**TEMPLEOGUE / RATHFARNHAM TO CITY CENTRE CORE BUS
CORRIDOR SCHEME**

SDCC SUBMISSION:

SID PLANNING APPLICATION TO AN BORD PLEANÁLA:

Date: March 2024

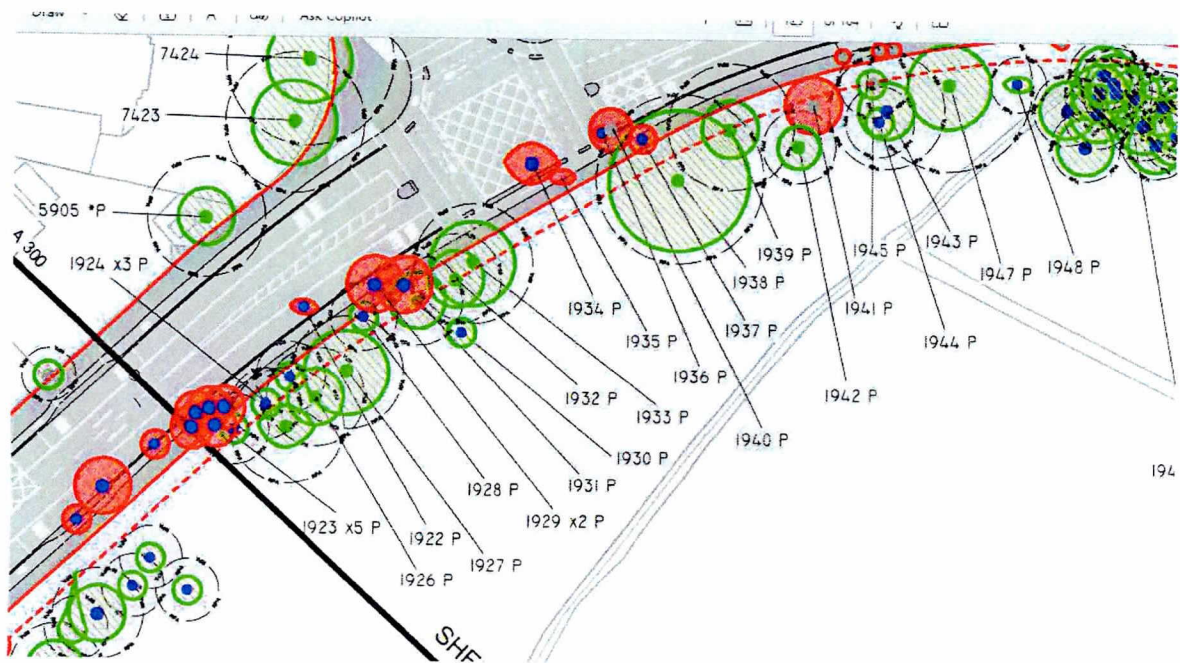
Another examples of this are the trees in the following screen shot of the submitted tree protection plan which would appear to show trees on the road side of the boundary wall when in fact they are located inside the wall and this would raise concerns regarding the accuracy of all the tree positions in this area.

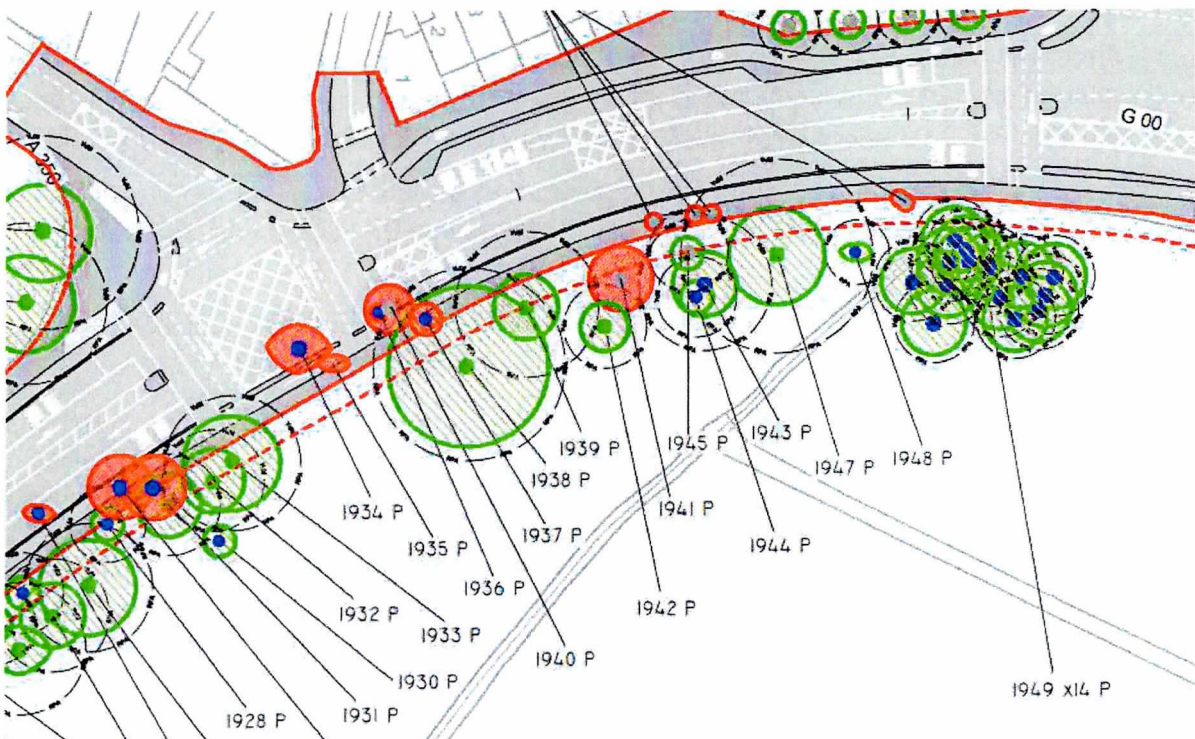
I would have concerns that when it comes to constructing these new surfaces which will transverse the root zone of these trees, that a No-Dig method may not be acceptable and that these surfaces will need to be built to a recognized road building standard. Even if they are to be installed using a No-Dig methodology, the placing of a more seal surface over the roots of the trees and changing of ground levels is likely to have some impacts on the health of these trees and possibly their long term retention. It is likely even if they are retained, that their condition will decline over time and there will be a need for their removal as part of future management and there will be a protracted impact on the treescape of this area although, new trees planted as part of the landscaping will be establishing and may help mitigate this visual impact to some degree for when the time comes for the removal of these trees.

Figure above shows Tree No.1947 a large mature Monterey Cypress whose calculate root zone extends out into the permanent land take area. The tree is located c.8m in from the existing boundary wall and the ground levels around its base are some 1m+ higher than the ground levels at the base of the current wall on the inside, so it is likely that excavation required to build the new wall and install the surfaces on the road side will require excavation and this will impact this tree and its stability may be so compromised by the works that it may even require removal to address health and safety.

Figure shows one such example of a service which will need to be installed within the new footpath surface and this will most likely run through the root zone of some trees being retained.

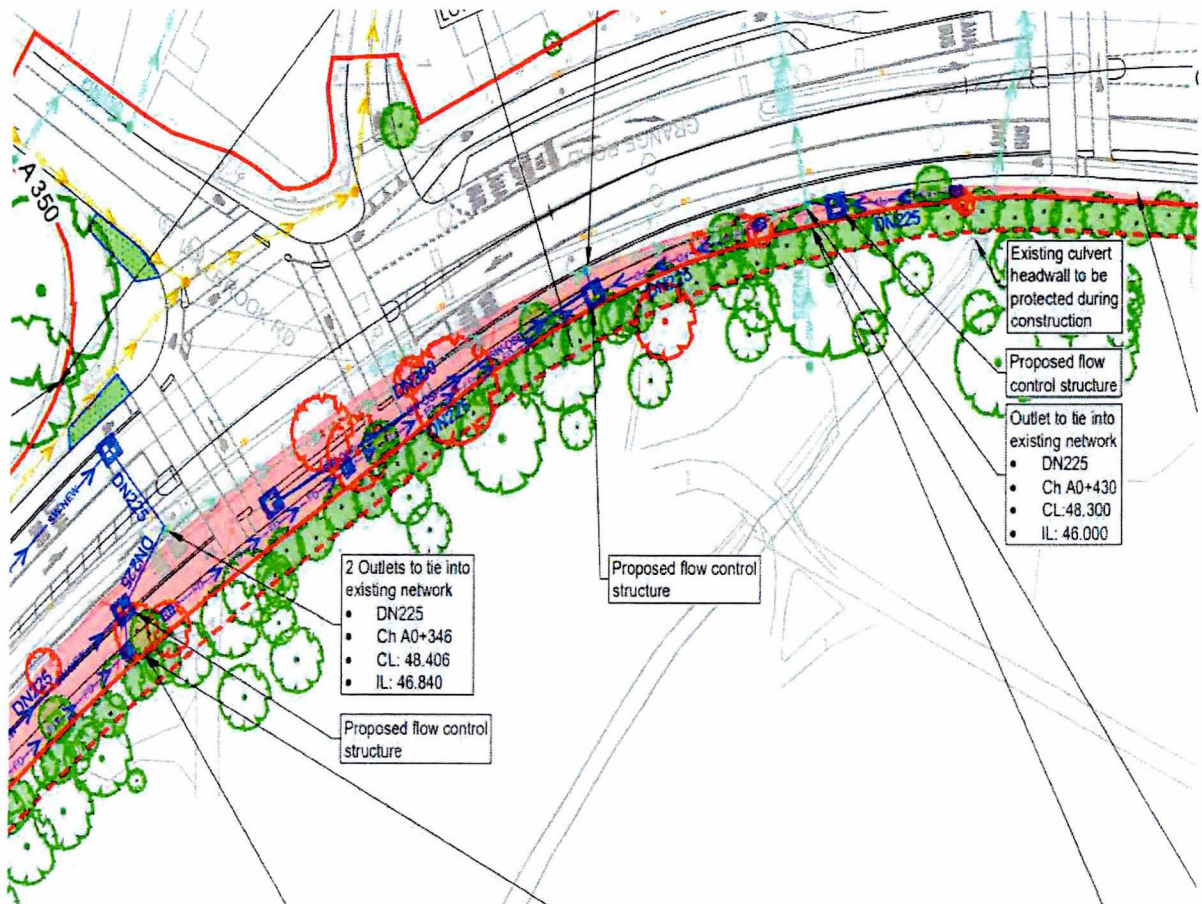
Reply: I would concur with the concerns raised by SDCC regarding services where they need to be installed within the root zones of the trees being retained.

There is always a risk that the services will not be able to be installed using trenchless technologies due to ground conditions and the accuracy of the installation by these techniques or even the risk of damaging other services in the process and so the only viable means of installing these services maybe via trenching which will result in some root damage even if done manually with the aid of an airspade and/or VAC truck as a lot of the small size roots below 25mm diameter will be removed to allow access. The depth of the service will also restrict its installation techniques and in particular, deep excavations will not be practical manually.

Figure shows the arboricultural tree protection plan of the same location as above and shows some of the calculated root zones of these trees to be retained extending out into the area where surfaces and services have to be installed.
